| <b>ITEM: 6.5</b> | <b>REPORT SUMMARY<br/>MINOR VARIANCE APPLICATION<br/>FILE NUMBER A177/23</b> |

## MINOR VARIANCE APPLICATION FILE NUMBER A177/23

| <b>PURPOSE OF APPLICATION:</b>                   | Relief from the Zoning By-law is being requested to facilitate the construction of Copper Creek Pumping Station. Relief is also being requested to recognize the existing lot size. |

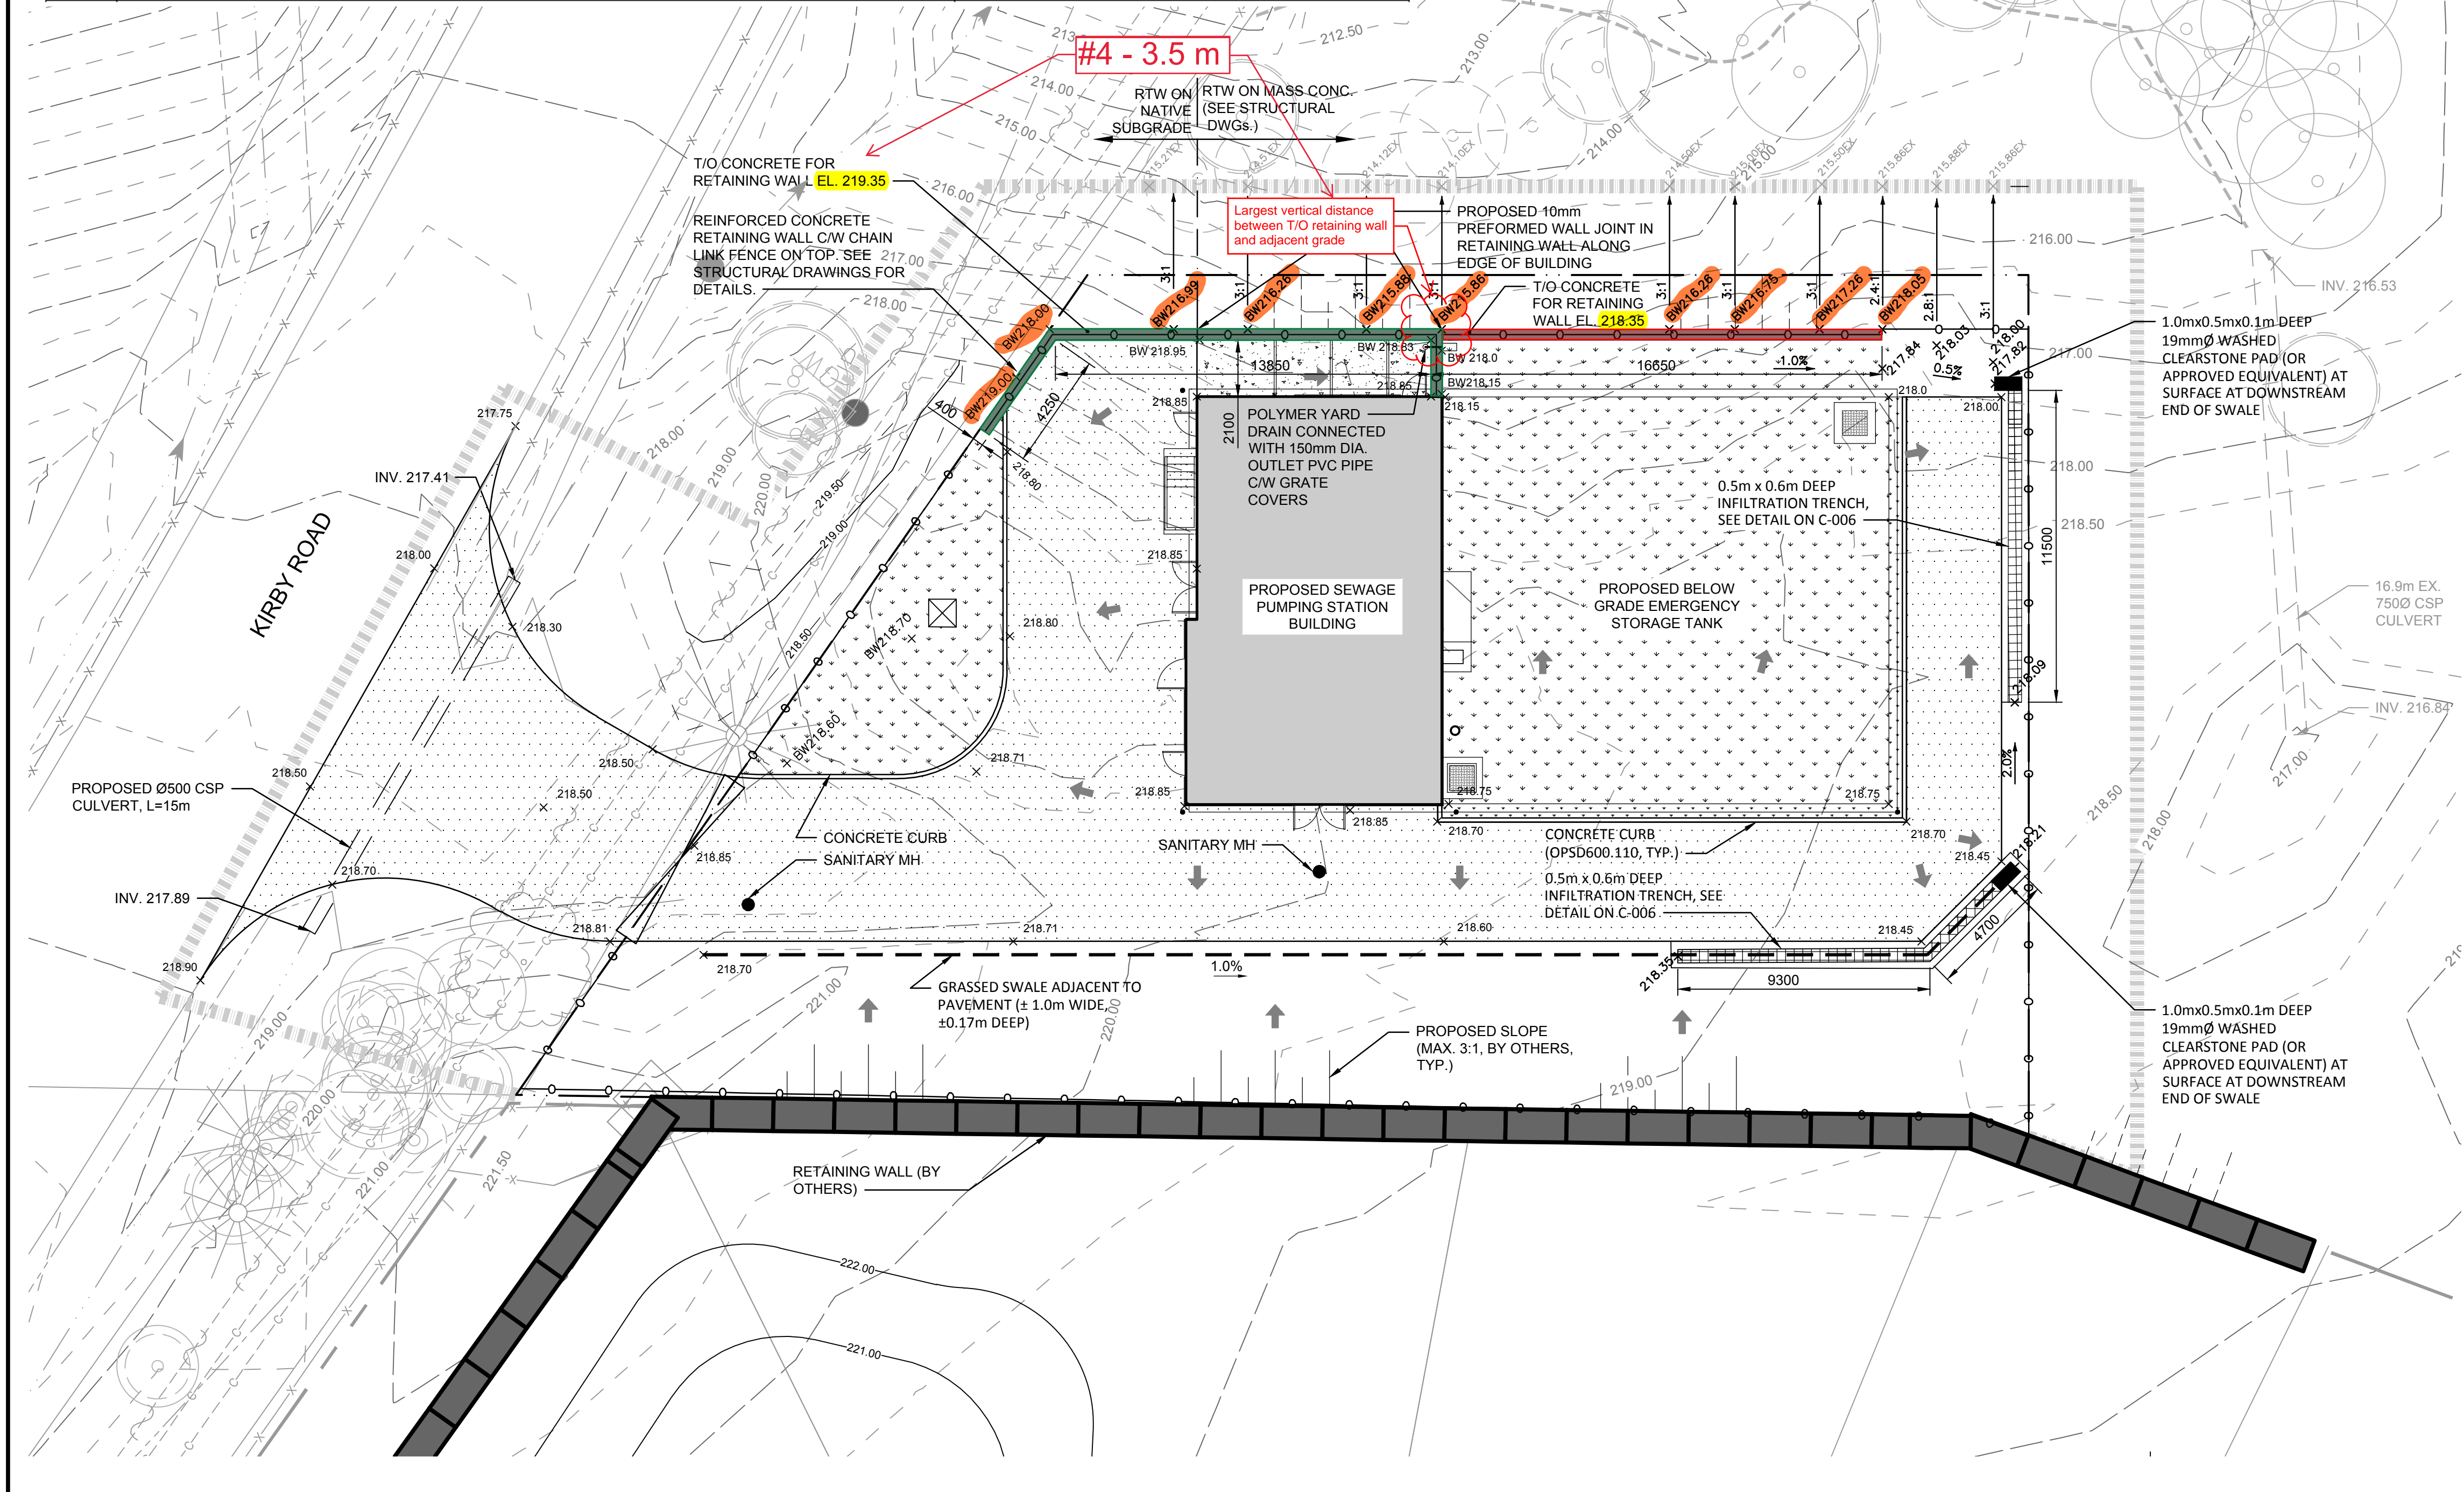
We request a site plan showing the entirety of the land, all existing structures and setbacks to those structures as we are now aware that the lot as shown on the site plan does not reflect the entirety of the parcel.

In the latest Site Plan drawing submitted in December 2023, the eastern property limit was shifted approximately 3.3 m west and the southern property limit was shifted approximately 0.6 m south, from the property limits shown in the Site Plan drawing included within the initial submission.
